Response to a Request for Further Information

In respect of SDCC Reg. Ref.: SD21B/0496 which relates to an Extension to an Existing Dwelling House at:

'An Uímh', Slade, Saggart, Co. Dublin, D24 CA36

South Dublin County Council Register Reference SD21B/0496

Figure 1.1: Comparison of North West Elevation Proposals

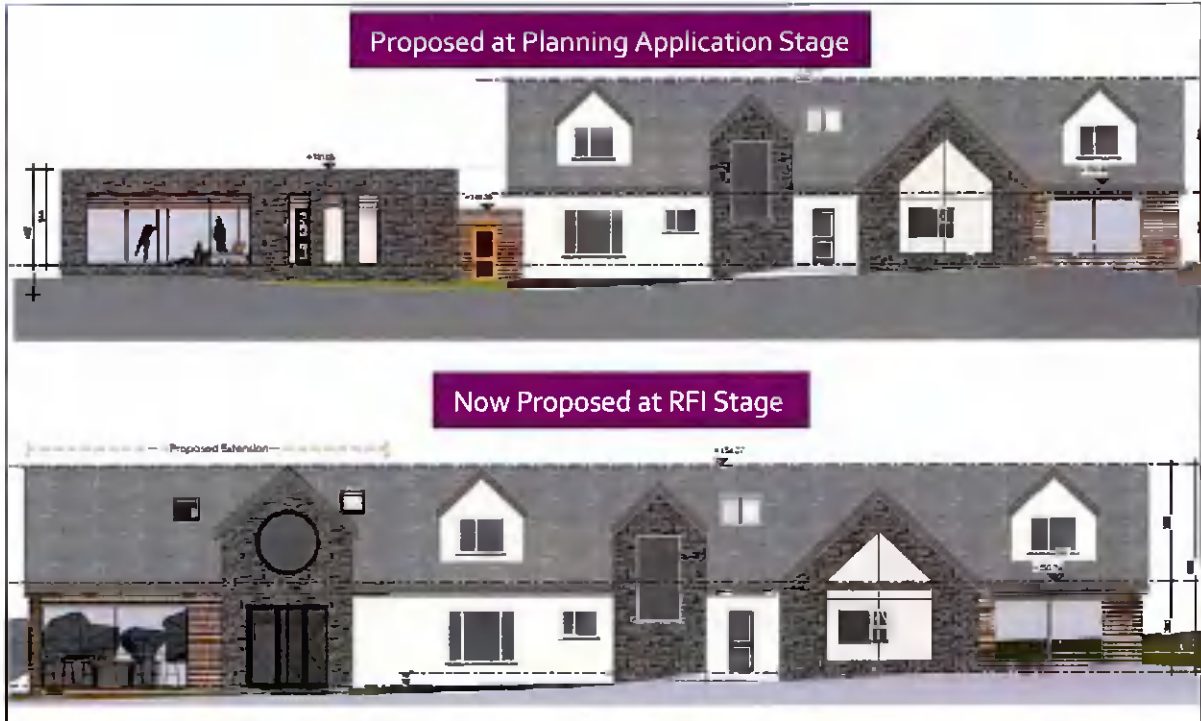
(iii) a drawing showing additional sustainable Drainage System (SuDS) features for the proposed development such as but not limited to:

- *Green sedum roof on proposed extension. (Refer also to other items in this AI request).*
- *Permeable Paving in all new hardstanding areas including driveway areas*
- *Water butts with overflow to proposed soakaways."*

Firstly, with regard to additional sustainable Drainage System (SuDS), a green sedum roof cannot be provided as the extension is now a pitched roof, as shown in Figure 1.1 below.
